**Re: Application No: SSI 15_7400, Sydney Metro City & Southwest - Chatswood to Sydenham.
Submission from the Joint Owners of the MLC Centre, 19-29 Martin Place, Sydney**

Submission from NSW Masonic Club – Castlereagh Boutique Hotel to the Director of Transport Assessments, Department of Planning and Environment Regarding the Sydney Metro City & Southwest – Chatswood to Sydenham Environmental Impact Statement (SSI 15_7400)

Submission from NSW Masonic Club –
Castlereagh Boutique Hotel to Director,
Transport Assessments, Department of
Planning and Environment Regarding the
Sydney Metro City & Southwest -
Chatswood to Sydenham Environmental
Impact Statement
(SSI 15_7400)

FIGURE 3 – RELATIONSHIP OF THE METRO PROJECT SITE TO THE CASTLEREAGH BOUTIQUE HOTEL

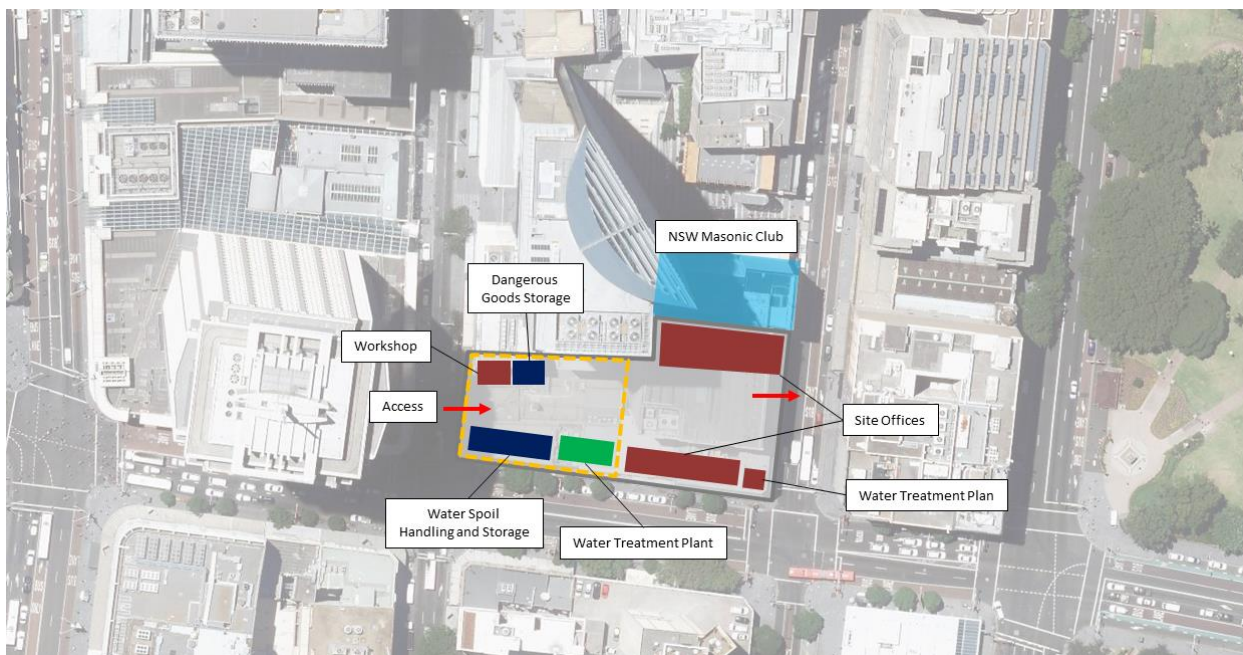
The EIS identified that during construction, generators will be located adjoining the boundary of the NSW Masonic Club and Castlereagh Boutique Hotel. It is requested that the acoustic impacts to Club members and Hotel guests are appropriately addressed by detailed construction management plans. The Club and Hotel must be consulted during preparation and approval of more detailed design and management plans to ensure all off-site acoustic impacts as a result of the Sydney Metro are mitigated.

Figure 8-38 Pitt Street Station construction vehicle movements

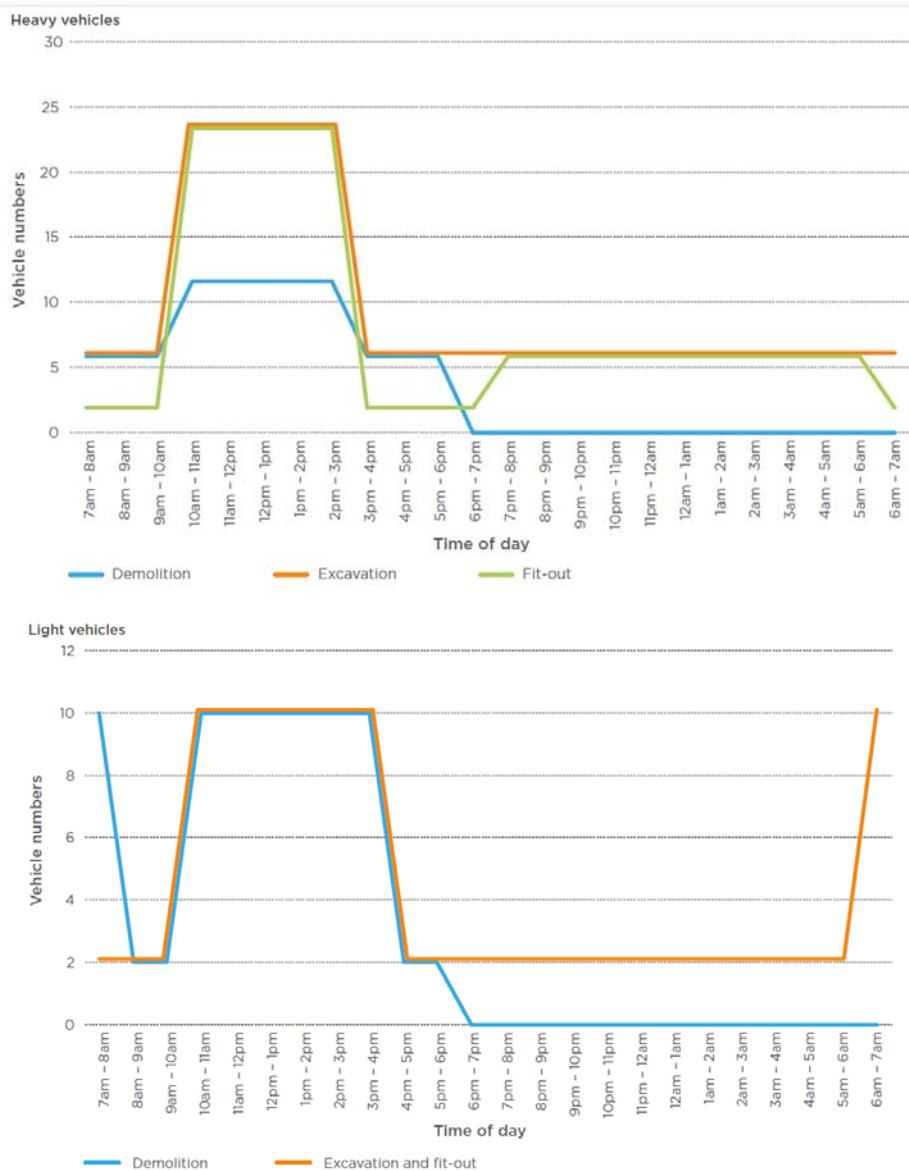
The figure of 234 excavation trucks would over a typical working day of, say 10 hours, would equate to around 3 trucks per minute which if split equally between the two sites would mean one truck leaving the site adjacent to hotel every 6 minutes throughout the working day.

It is noted that construction vehicles will load and unload inside the construction site to minimise impacts to bus travel times along Elizabeth, Castlereagh and Park streets so there will be **no construction trucks parked on-street along Castlereagh Street.**

FIGURE 11 – SECTION SHOWING INDICATIVE RELATIONSHIP WITH PROPOSED TUNNEL SHAFT

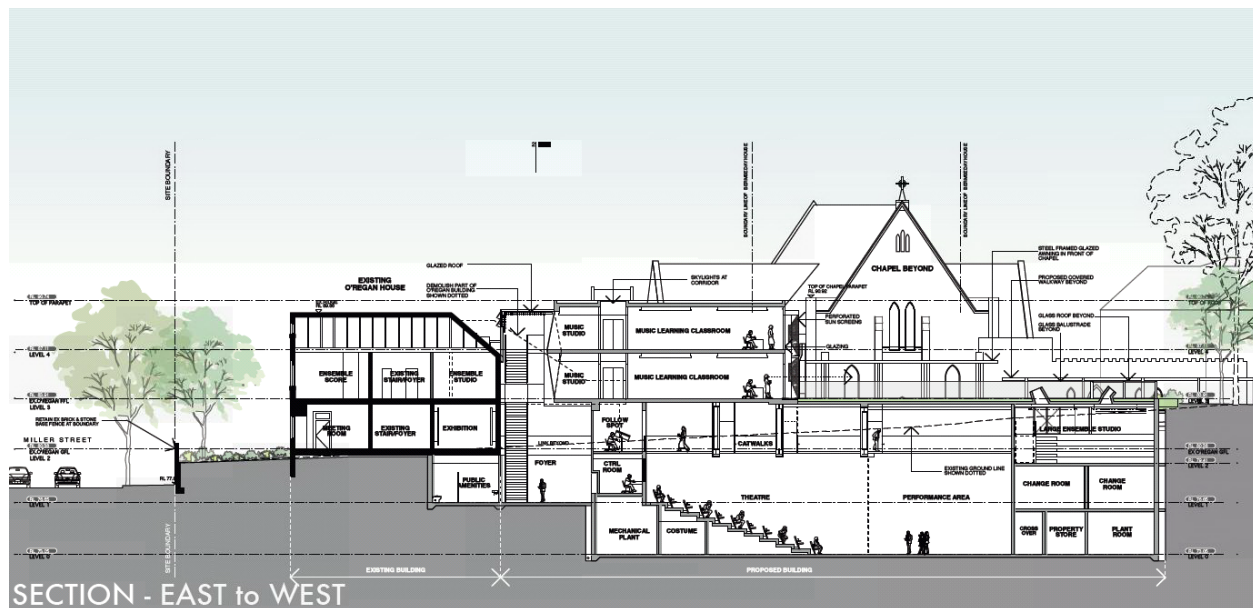
These plans illustrate how close the proposed tunnel is to the existing arts and cultural common and the significant potential for impact.

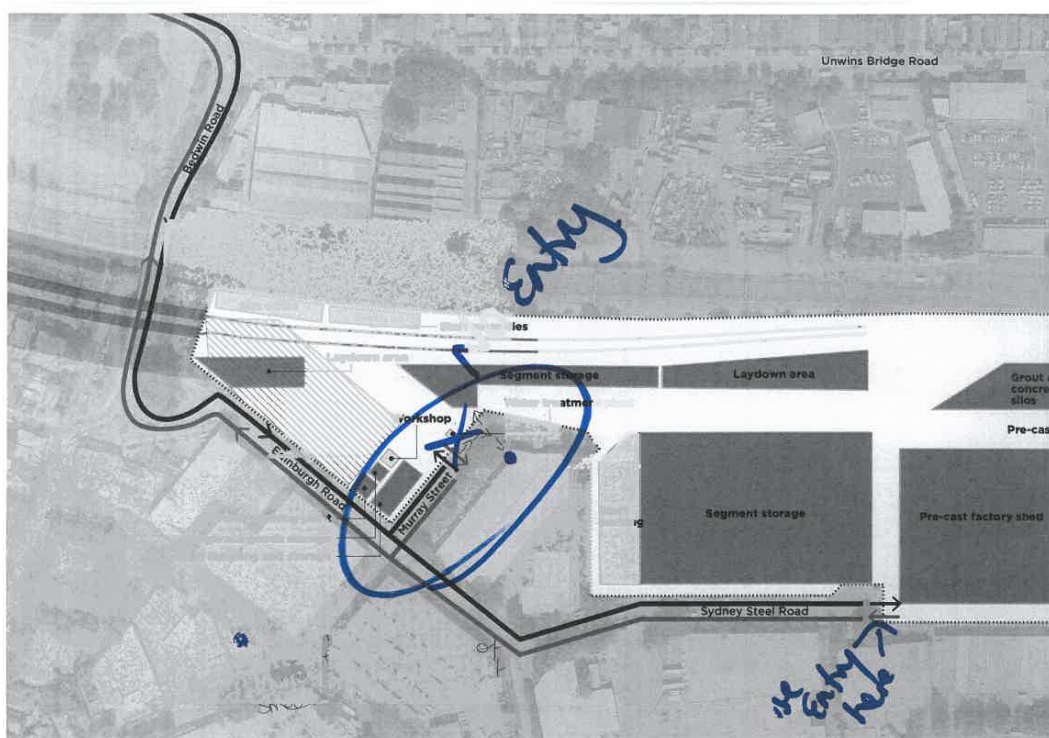
Another issue is the trucks that access our premises are quite large; 40 foot semi-trailers that cannot simply fit into our driveway, they use the elbow end of Murray Street to turn around/reverse and drive back to the street to exit at Edinburgh Rd. Therefore the proposal of closing the elbow end of Murray Street is not acceptable and is a huge detriment to our business's daily operations and you will need to look for an alternative entry.

(our driveway, you can see they can only enter into driveway to do delivery and reverse back into Murray st, to exit at Edinburgh Rd)
